**RECALL BULLETIN:**  
91209FRV

**PRODUCT(S) AFFECTED:**  
Jamboree Sport, Tioga Ranger with serial numbers listed in this Bulletin

**MODEL(S) AFFECTED:**  
25G

**SUBJECT:**  
Reroute Propane Plumbing Away From Chassis Suspension

Figure 2

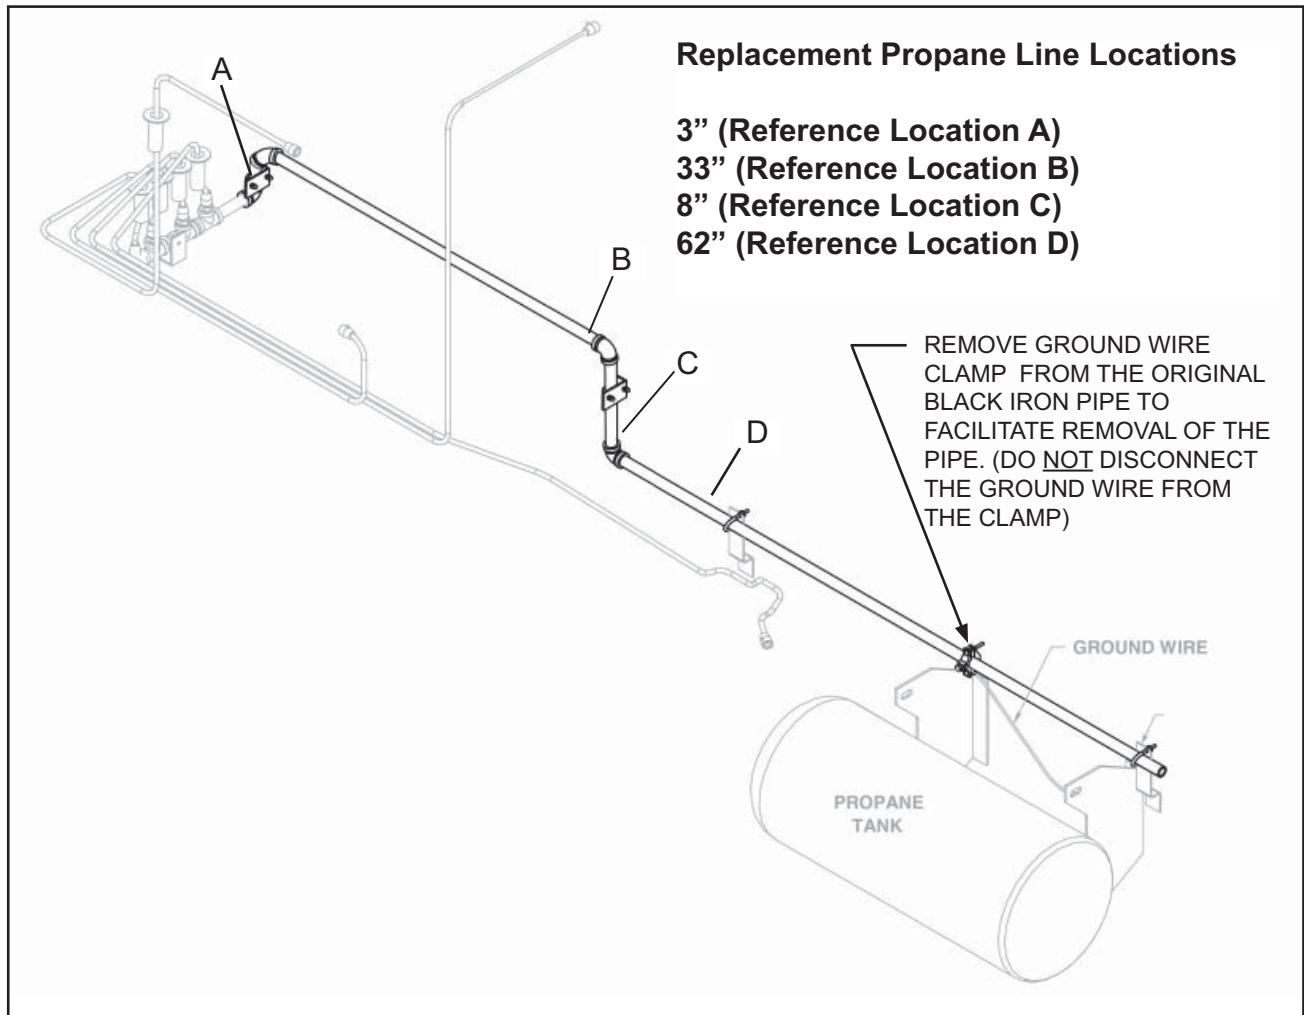
The black iron Propane plumbing, located under the motor home, may come into contact with chassis components and, under certain conditions, become pinched or crushed. This may result in a propane gas leak and the potential for an explosion and/or fire.

**NOTE:** The bold lines shown in Figure 2 (next page) illustrate the portions of propane plumbing that are to be removed and replaced in the following steps.

15. Remove and discard the two sections of black iron propane pipe and the two black iron elbows that were originally routed between the propane manifold and the propane tank flexible hose. Refer to Figure 2.

Refer to Figure 2 to locate and install the new sections of propane plumbing.

16. Blow compressed air through all new plumbing sections to remove debris before installation.
17. Connect a new 90° elbow to one end of each of the following three lengths of new pipe, and tighten:
  - 3" (Reference Location A)
  - 33" (Reference Location B)
  - 8" (Reference Location C)

**NOTE:** When the manifold is reinstalled in the next step, the pipe nipple will be vertical, and the elbow attached to its top end will face the front of the motor home, as shown in Figure 2, Reference Location A.

21. Attach the new 33" length of pipe to the elbow on the end of the 3" pipe nipple. (This length will span the area across the wheel well.) Tighten the connection until the elbow at the other end faces down. See Figure 2, Reference Location B.

22. Attach the new 8" section of pipe to the elbow connection for the 33" pipe installed in the previous step. Tighten until the elbow at the other end faces the front of the motor home. See Figure 2, Reference Location C.

23. Attach the new 62" section of pipe to the elbow connection for the 8" section of pipe installed in the previous step. Tighten. See Figure 2, Reference Location D.

24. Relocate the support brackets for the propane pipe as required, then install new U-bolts to secure the Propane plumbing. Fasten each U-Bolt with two new flat washers and two new locking nuts. Add additional support brackets and U-bolts (with fastening hardware) as required. The black iron pipe must be secured within 6" of connections (elbows) at end of runs, and at intervals not to exceed 48" on center.
